**CITY OF ST. HELENS PLANNING DEPARTMENT
STAFF REPORT
Appeal AP.2.24 – AP.6.24 (CUP.2.24 & V.8.24 - V.11.24)**

DATE: January 3, 2025
TO: City Council
FROM: Jacob A. Graichen, AICP, City Planner

APPLICANT: Dan Hatfield
OWNER: LAGRAND TOWNHOMES LLC

ZONING: General Residential, R5
LOCATION: 5N1W-34CC-09200; NE corner of the Wyeth and N. 5th Streets intersection
PROPOSAL: Build a triplex on formerly developed lot with multiple Variances

SITE PLAN

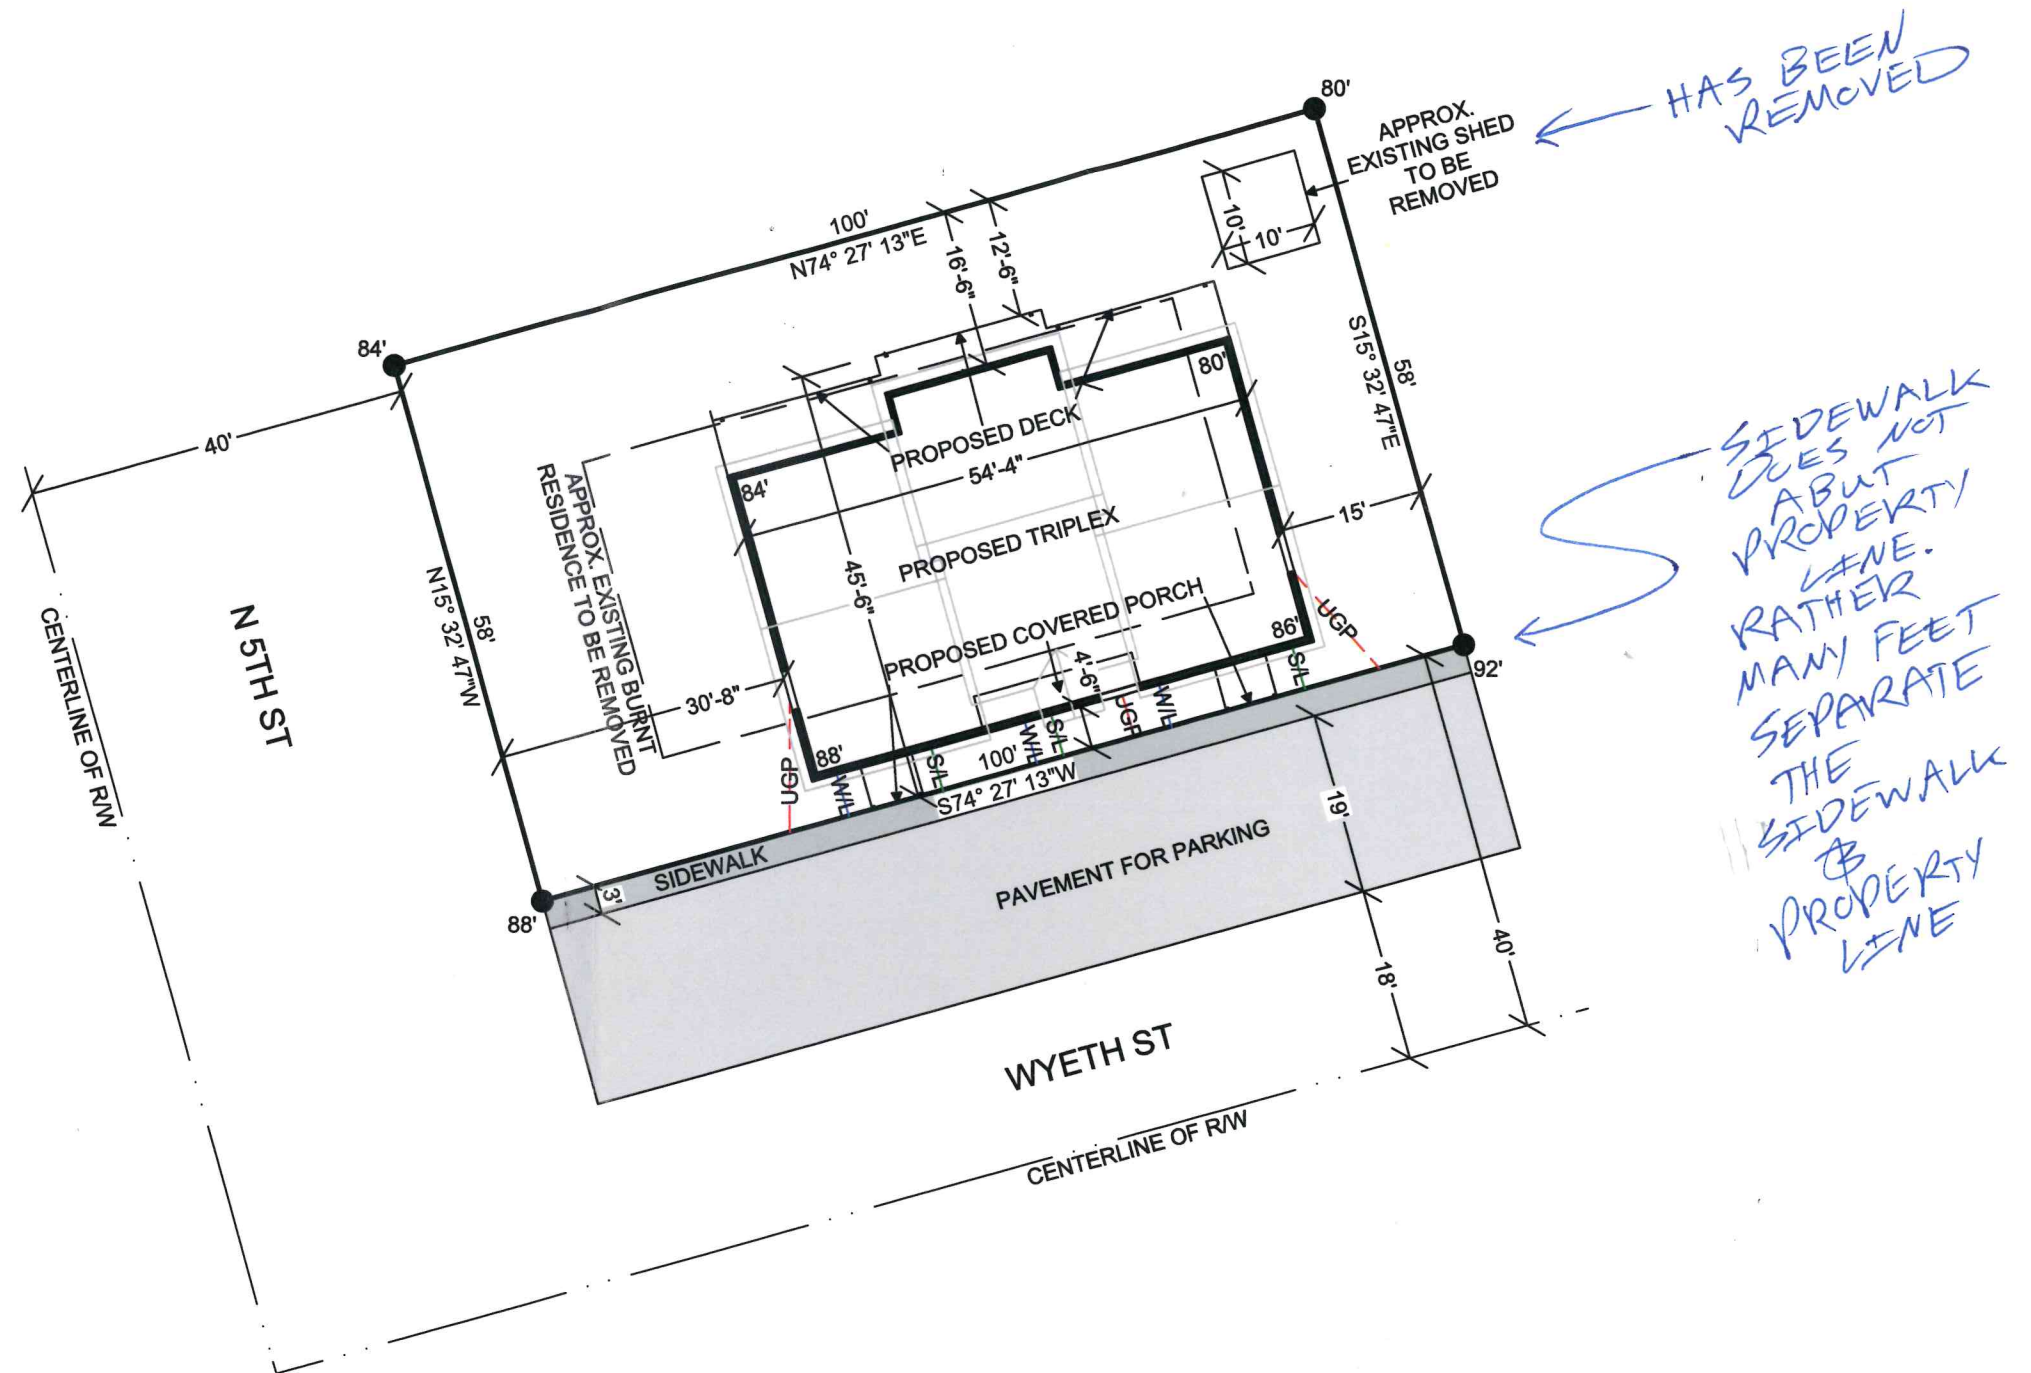
Min front yard (from N 5th Street) is 20 feet. Site plan shows approximately 30’.

Min rear yard (opposite N 5th Street) is 10 feet. Site plan shows 15 feet.

Min exterior yard (corner lot) along Wyeth is 10 feet. Site plan shows 4.5 feet. **Need Variance:** see V.9.24. This was denied by the Commission.

Min side yard (opposite Wyeth) is 10’ for multifamily structures. Site plan shows 12.5 feet.

Maximum building/structure coverage is 50% for multifamily development. ½ of the lot size is 2,900 square feet. The sole building proposed has a footprint of approximately 2,200 square feet.

Non-living windowed room areas are along the Wyeth Street side of the building. Provided the existing sidewalk does not move (which is shown incorrectly on the preliminary plans as the sidewalk does not abut the property line), there should be 8' of separation, but maybe not 10 feet. Living room areas are proposed on the opposite side of the building from Wyeth Street.

FRONT ELEVATION
SCALE: 1/4" = 1'-0"

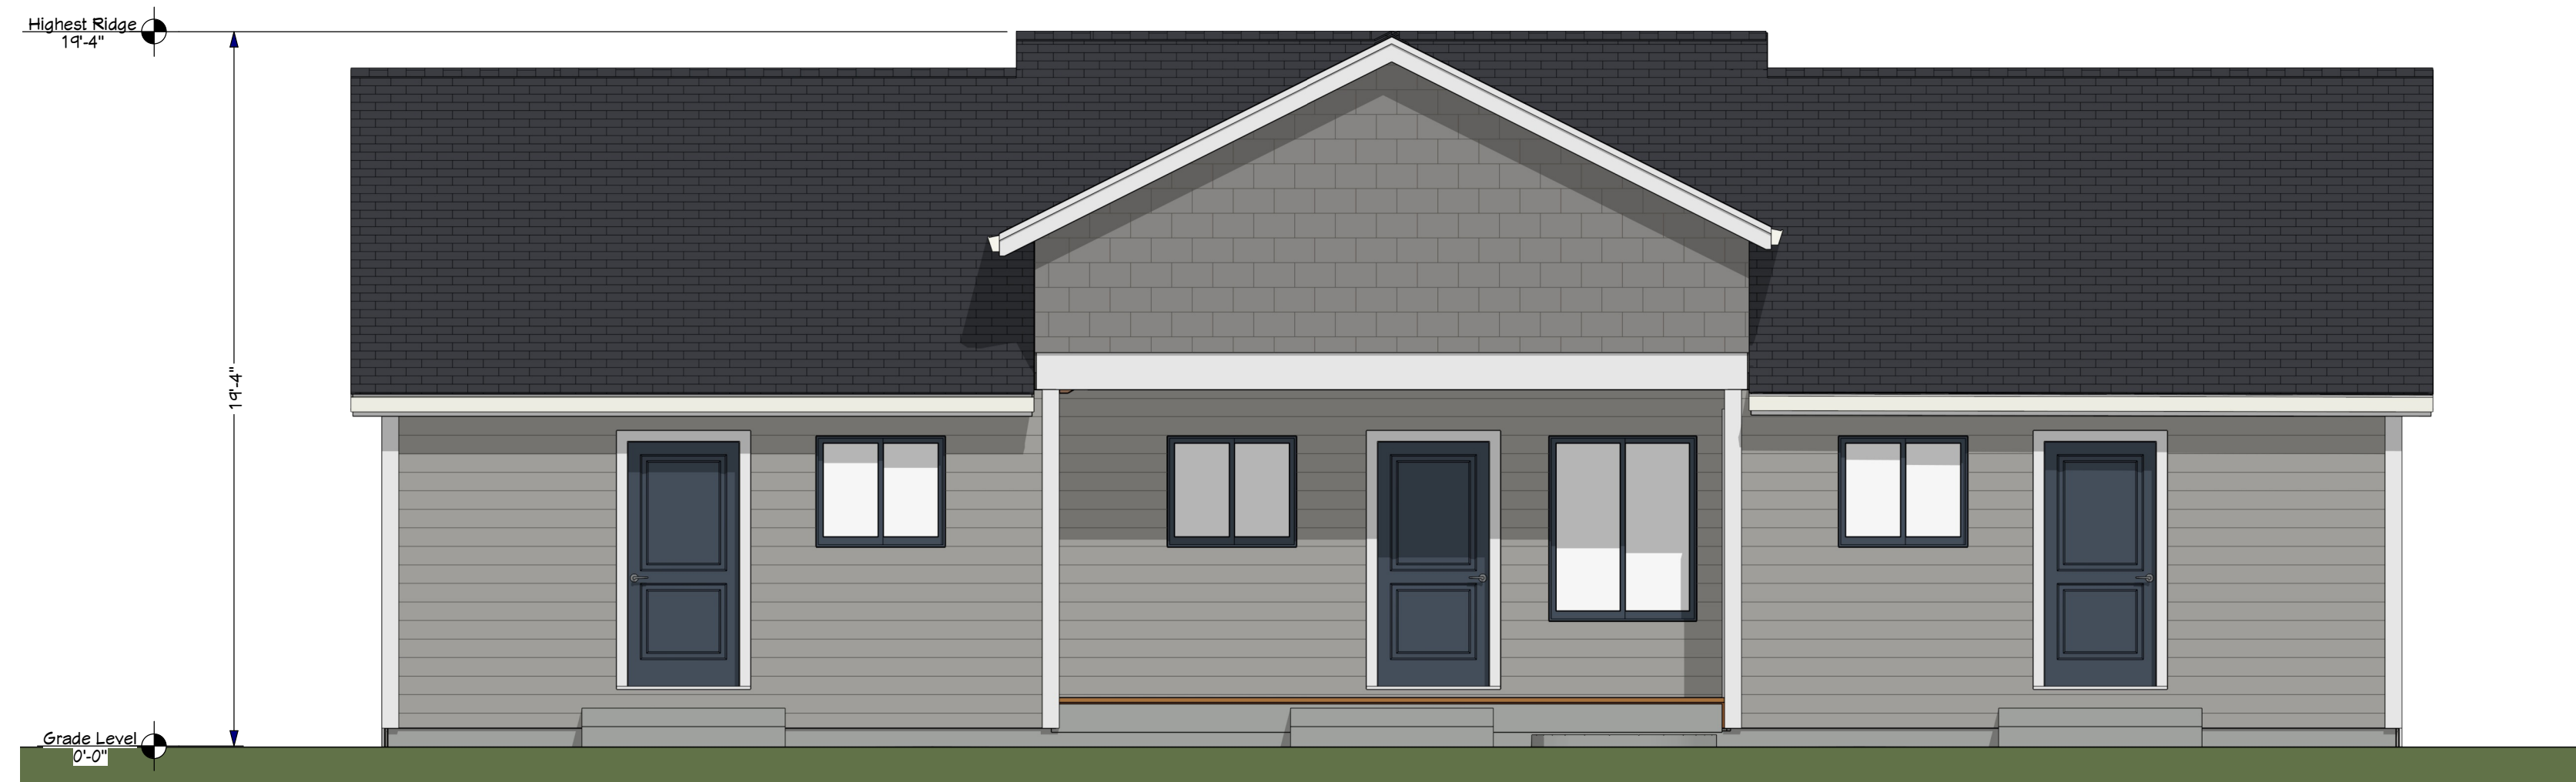
This is not met, but the proposed building has some offsets, but not 8’ ones and the roof line break is only one foot. This doesn’t necessarily kill the CUP by itself, but significant plan modification would be necessary.

This is not met; **Need Variance:** see V.10.24. The Commission denied this Variance.
